DESIGN <i>DC</i>	DRAWN BY <i>DC</i>	DART AEROSPACE LTD HAWKESBURY, ONTARIO, CANADA	
CHECKED <i>B</i>	APPROVED <i>H</i>	DRAWING NO. DSI 9381	REV. A SHEET 1 OF 1
DATE 07.06.05		TITLE SHOCK ABSORBER SLOT CORRECTION NTS	
A	07.06.05	NEW ISSUE

DART SERVICE INSTRUCTION

TO AMEND INSTALLATION INSTRUCTIONS IIN-D350-748 Rev. A
REF. CANADIAN STC: SH06-27
REF. FAA STC: SR02359NY
REF. EASA STC: IM.R.S.01280

HALF CLAMP INSTALLATION DETAIL ON
D350-748-101 CROSSTUBE.
AS 350/355 HIGH FWD
(VIEW LOOKING FWD)

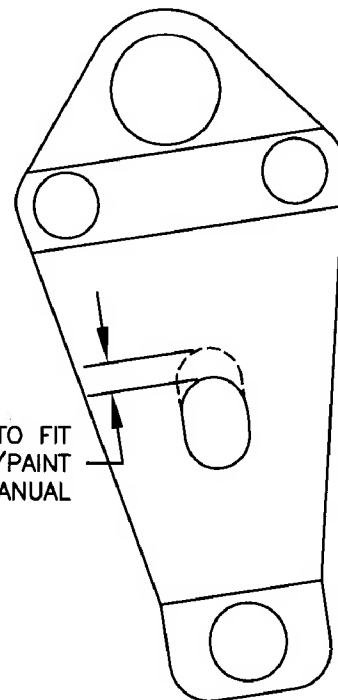
The shock absorber mounting hole on D350-748-101 High Fwd Crosstubes B/N 31013, 31014, 31015, 31016, and 31017 is misaligned with the 350A41-1042-22 Half Clamps.

To correct this situation, it is acceptable to enlarge the slot in the 350A41-1092-22 half clamps as shown. Enlarge slot the minimum amount possible so that bolts will pass through.

ENLARGE SLOT TO FIT
DEBURR AND TOUCH UP PRIME/PAINT
PER AIRCRAFT MAINTENANCE MANUAL

Install reworked 350A41-1092-22 Half Clamps (or equivalent) per Installation Instructions IIN-D350-748.
